## **ANNEXURE A1**

### **Proposed Designation and Consent Conditions**

**23 June 2011**

This shows amendments from the “red book” set of Proposed Conditions dated 25 March 2011. The parties’ experts’ responses (13 May 2011) as directed are shown in purple line changes, and amendments made by the Board with its draft Report (25 May 2011) are shown in red line changes.

Figure DC.B – OPW2 Southern Ventilation Buildings and Stack

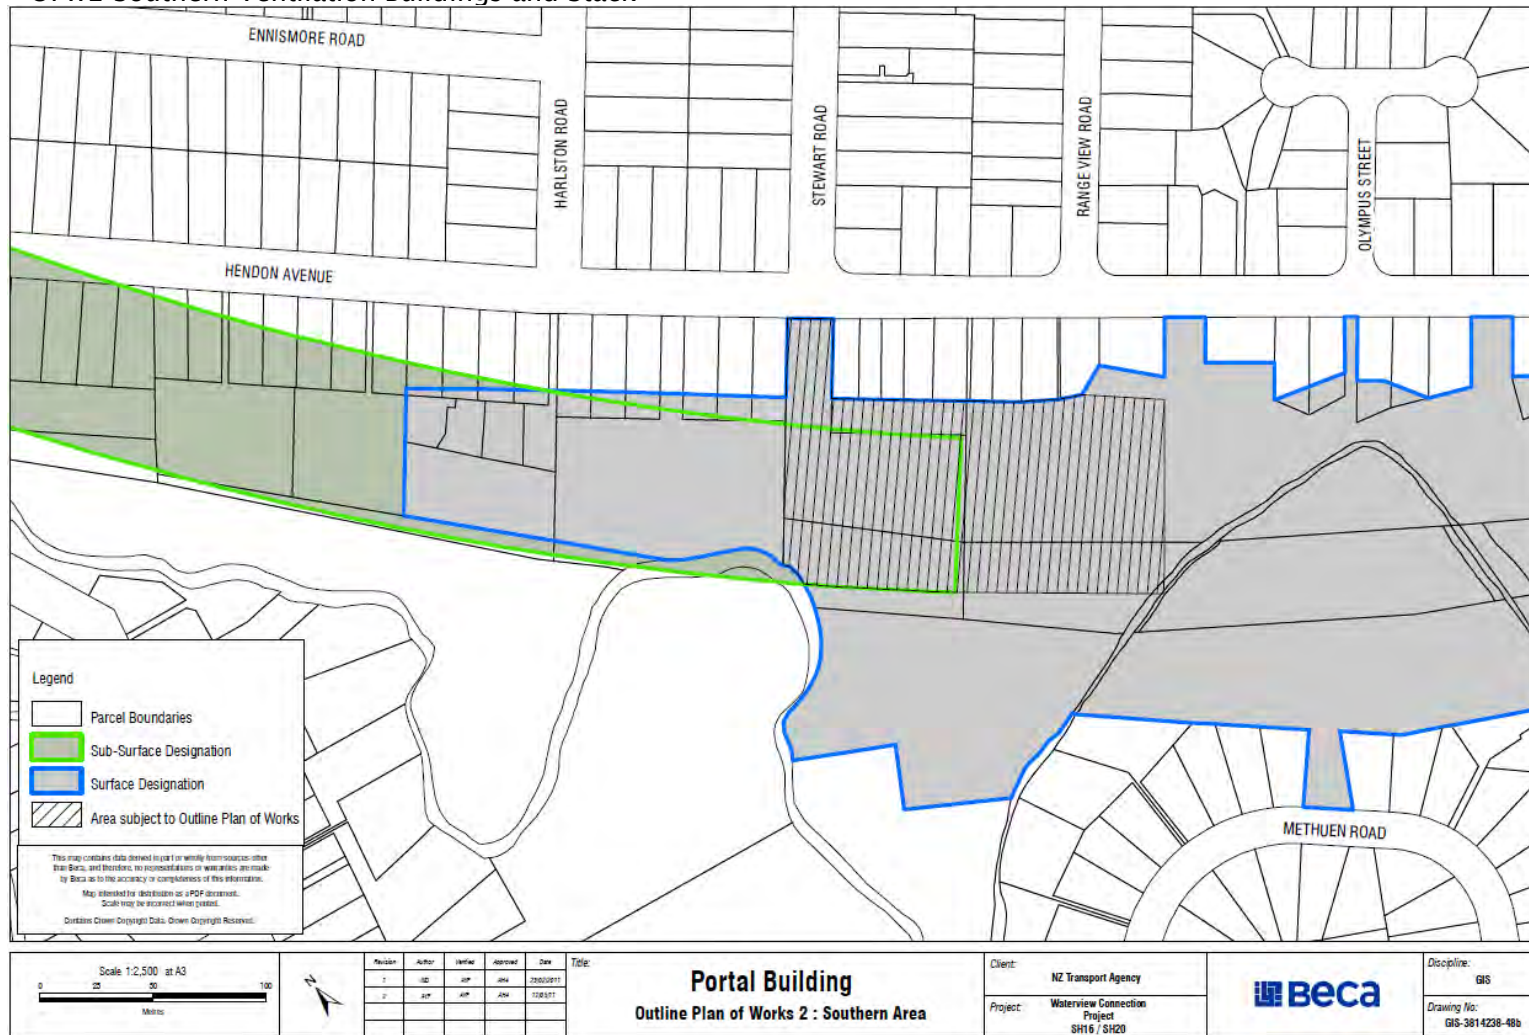
DC.9	<p>Outline Plan of Works for the Southern Ventilation Building, <u>Control Building and Stack</u> <del>(which include the southern ventilation building and control building but preclude the</del></p>

~~inclusion or attachment of equipment for any activity unrelated to the tunnel operation and its ventilation system~~ and Ventilation Stack (OPW2) (Refer Figure DC.B).

- (a) Retention of the same building / structural components underground as per the revised Drawing Set F.8, ~~specifically Drawings of Vent South Option 003 / 003A~~ (refer Schedule A, Row 9);

- (b) Creation of an above ground building ~~slim, linear plan~~ arrangement that maximises the separation of the buildings from the houses on Hendon Avenue to the east and the pedestrian / cycle way to the west;

- (c) ~~The location of facilities, accessways, parking and manoeuvring areas to be in general accordance with the revised Plans of Drawing Set F.8, specifically Drawings of Vent South Option 003 / 003A (refer Schedule A, Row 9),~~ providing for a ~~subject however to that relating to a shift of between 70 - 80m to the south east from the position shown in the application documents, the final decision within that 10m range to be taken by the NZTA, to the approval of Major Infrastructure Team Manager, Auckland Council, after consultation with the Community Liaison Group for Owairaka established under Condition PI.5;~~
